8605050111 860429
PDR ADOCK 05000305
P PDR

Proposed Amendment No. 71
04/29/86

KEWAUNEE UNIT NO. 1 COOLANT HEATUP LIMITATION CURVES
 APPLICABLE FOR PERIODS UP TO 15 EFFECTIVE FULL POWER YEARS

Figure TS 3.1-1
 Proposed Amendment No. 71
 04/29/86

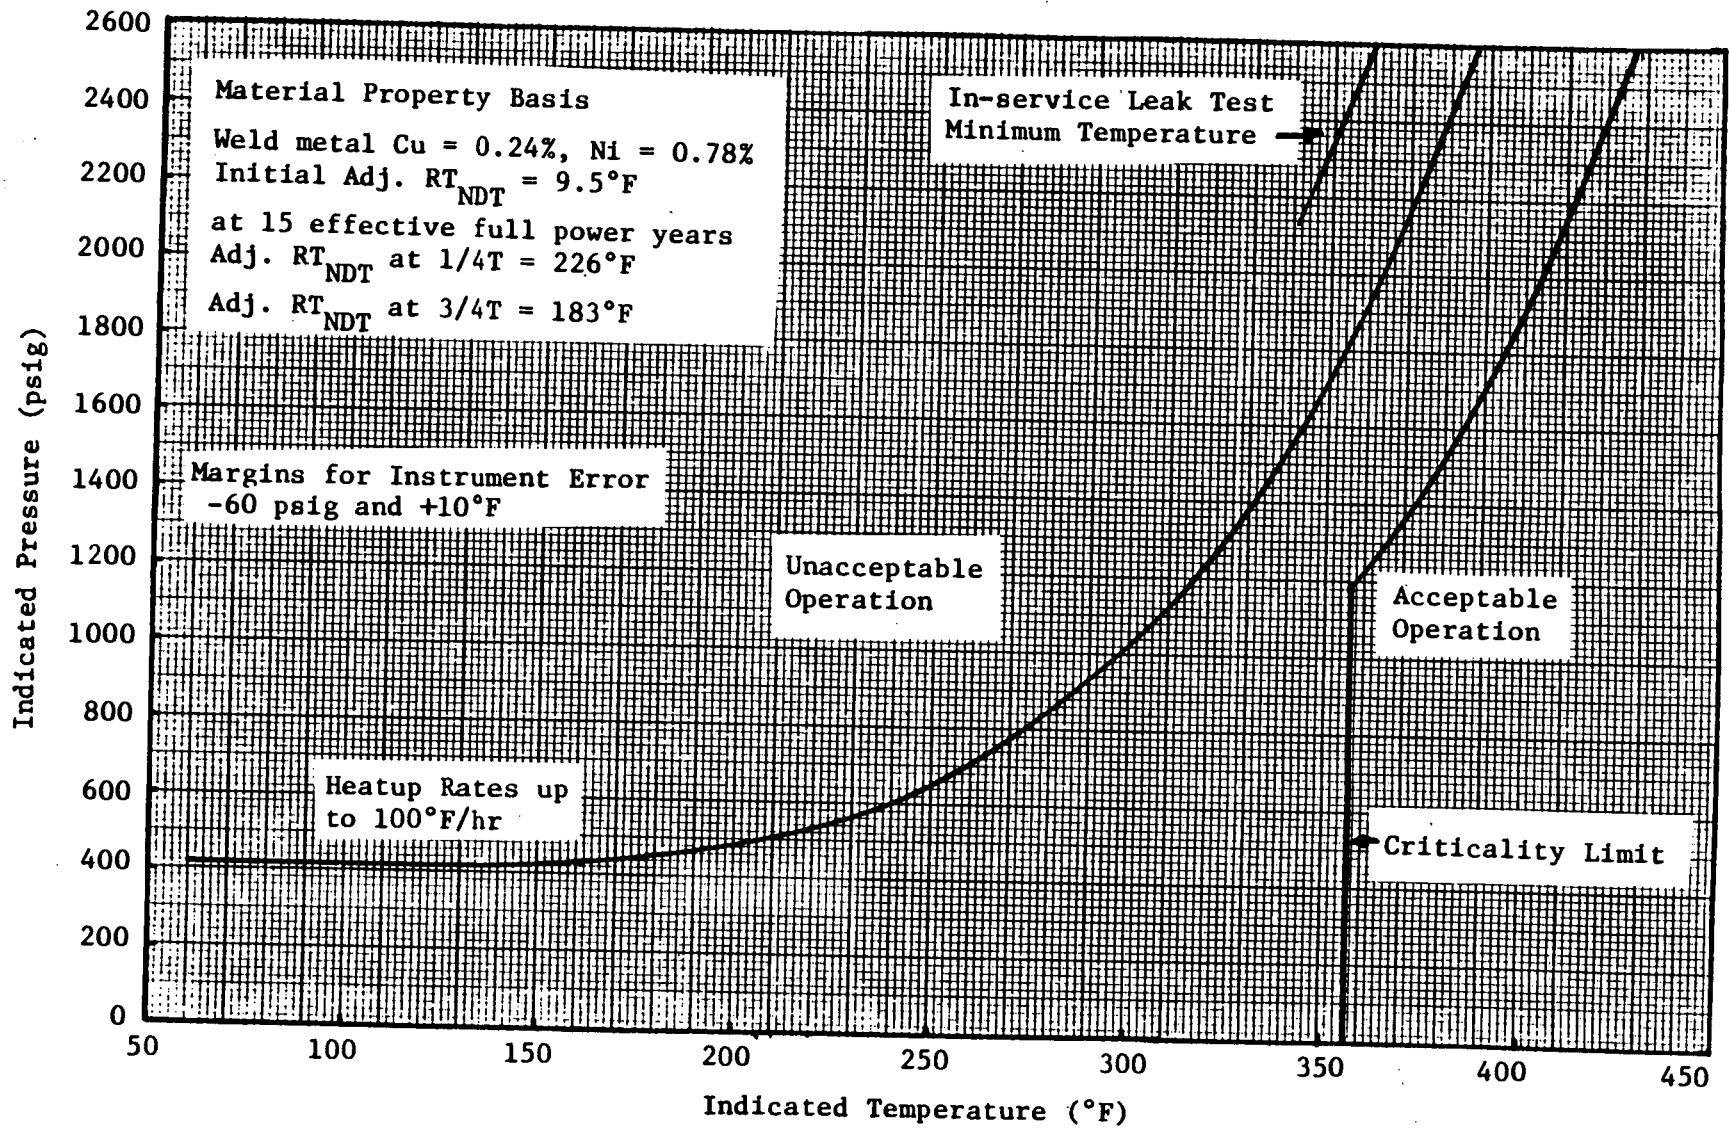
1. The reactor coolant temperature and pressure and system heatup and cooldown rates (with the exception of the pressurizer) shall be limited in accordance with Figures TS 3.1-1 and TS 3.1-2 for the service period up to 15 equivalent fullpower years.

- b. Figures TS 3.1-1 and TS 3.1-2 define limits to assure prevention of non-ductile failure only. For normal operation other inherent plant characteristics, e.g., pump heat addition and pressurizer heater capacity may limit the heatup and cooldown rates that can be achieved over certain pressure-temperature ranges.

The results of Irradiation Capsules V and R analyses are presented in WCAP 8908 and WCAP 9878, respectively. Heatup and cooldown limit curves for normal operation of the reactor vessel are presented in Figures TS 3.1-1 and TS 3.1-2 and represent an operational time period of 15 effective fullpower years.
